TOWN OF FRANKLIN

March 10, 2025

Re: Prospect Street Culvert Repairs – Peer Review Comments Amendment

Prospect St. Culvert Resource Areas

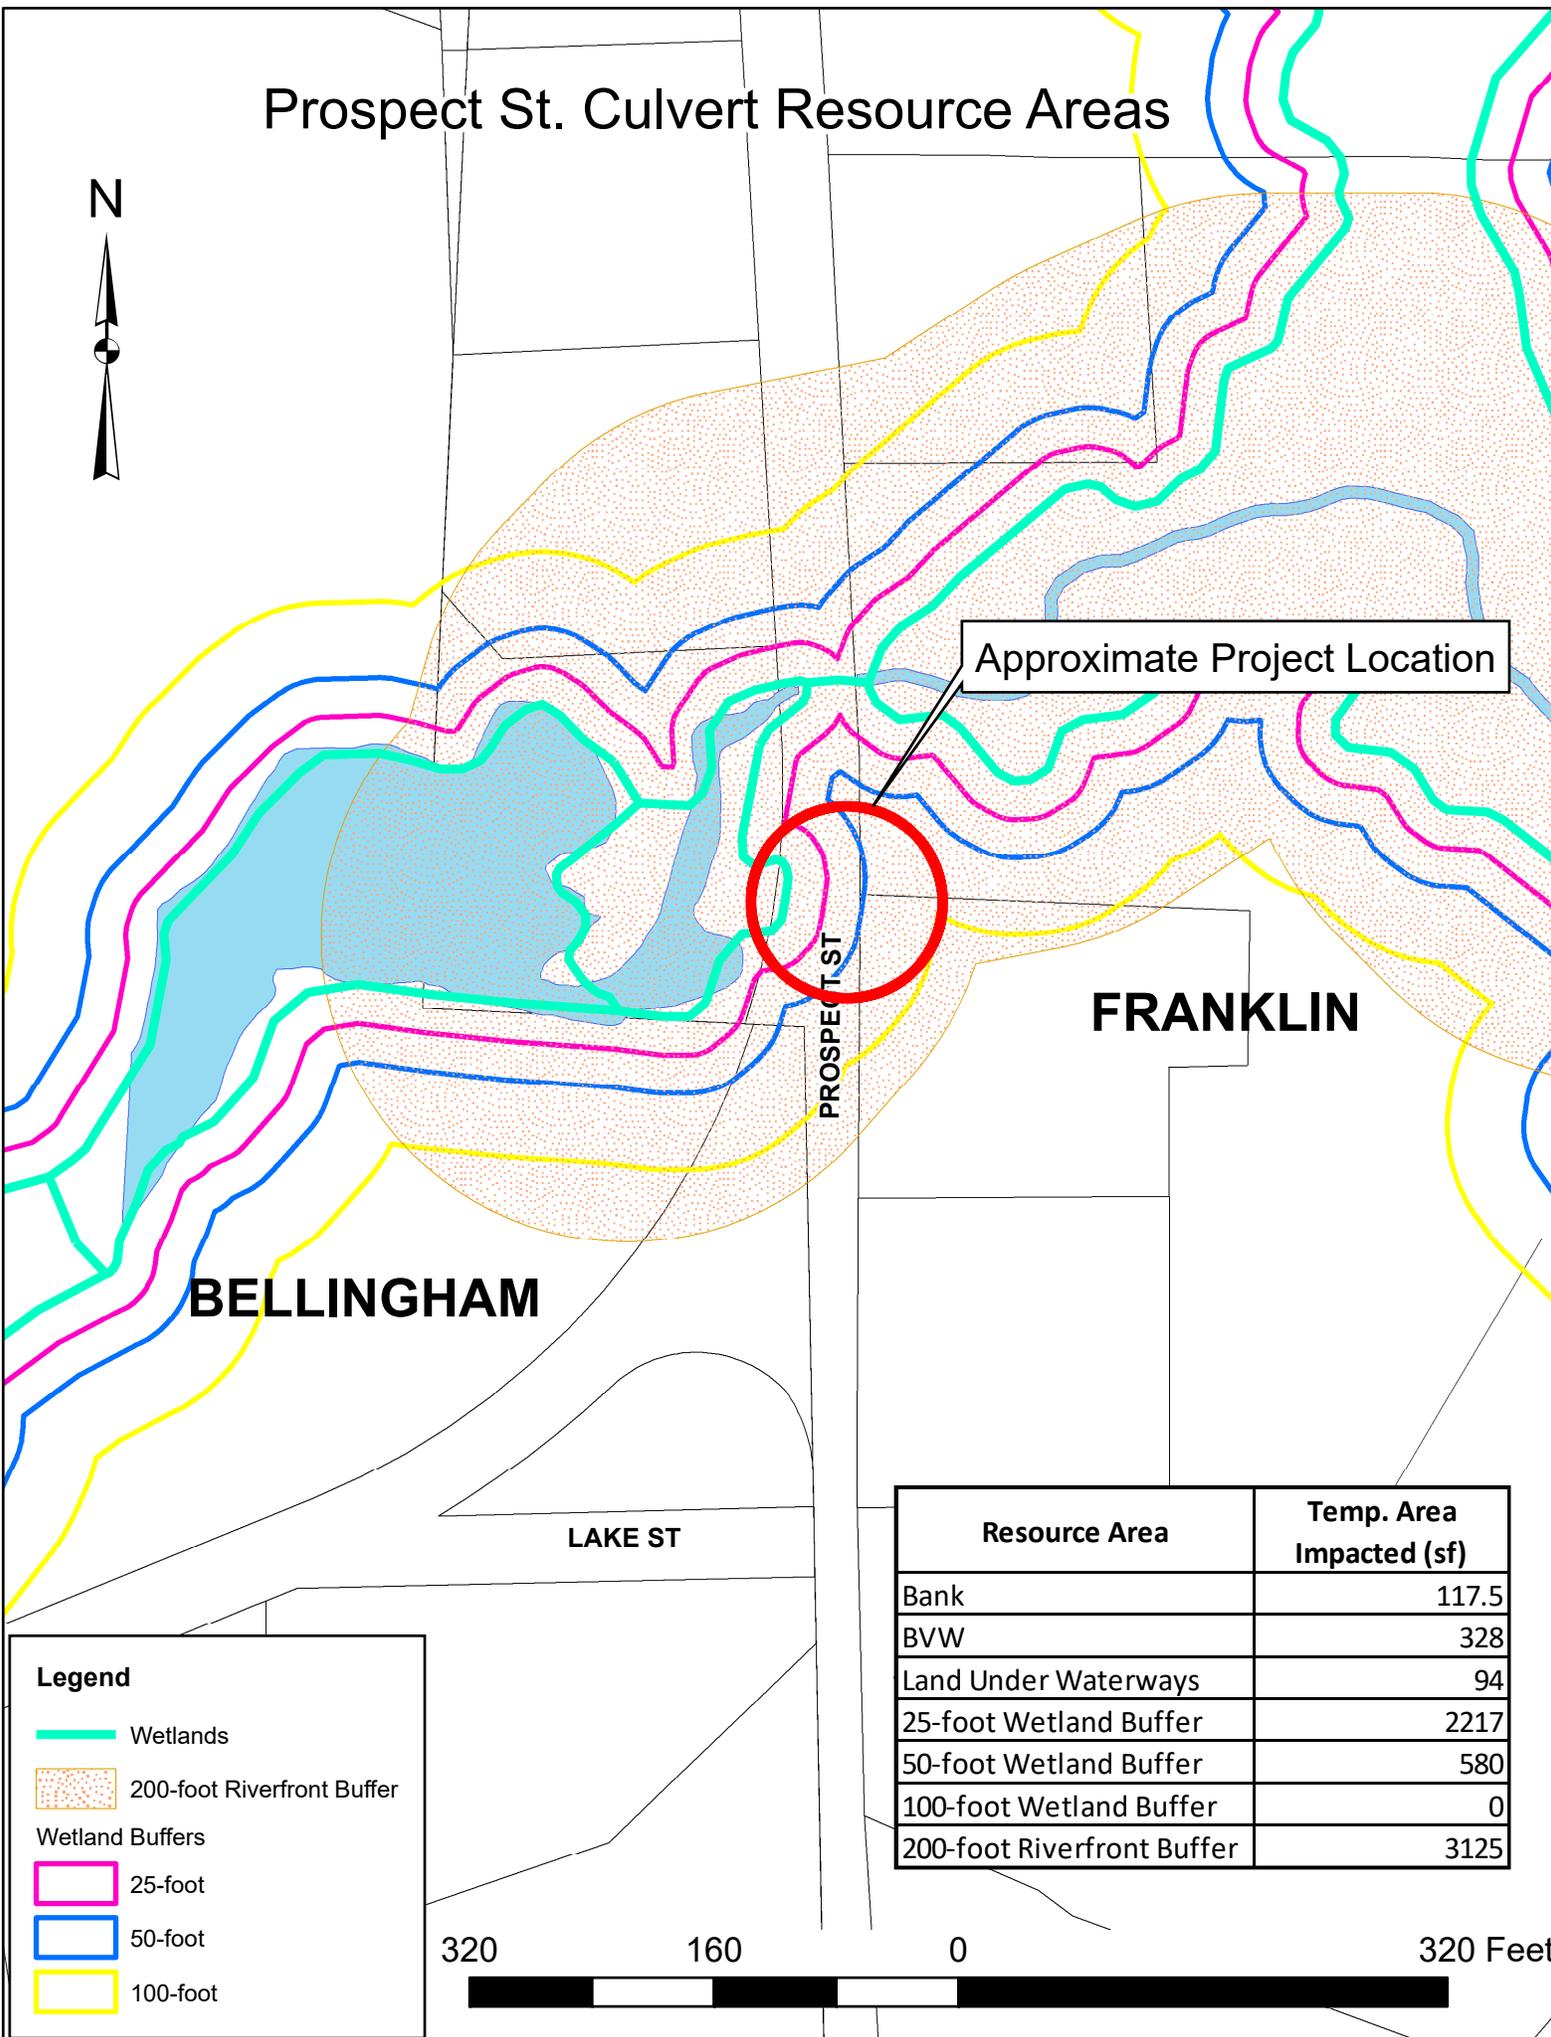
- b. Buffer Zones should be shown on the plans per Bylaw Regulation Section 7.18.1.8.

BETA2: BETA defers to the Commission on the approval of the plans without the 25-foot, 50-foot or 100-foot Buffer Zones shown.

A3. The locations of Resource Area impacts should be labeled on the Plans.

BETA2: Locations of the reported Resource Area impacts are not included on the plans – comment remains.

DPW2: A separate GIS map has been included in this submission identifying Resource Area Impacts.

DPW2: A separate GIS map has been included in this submission identifying Resource Area impacts.
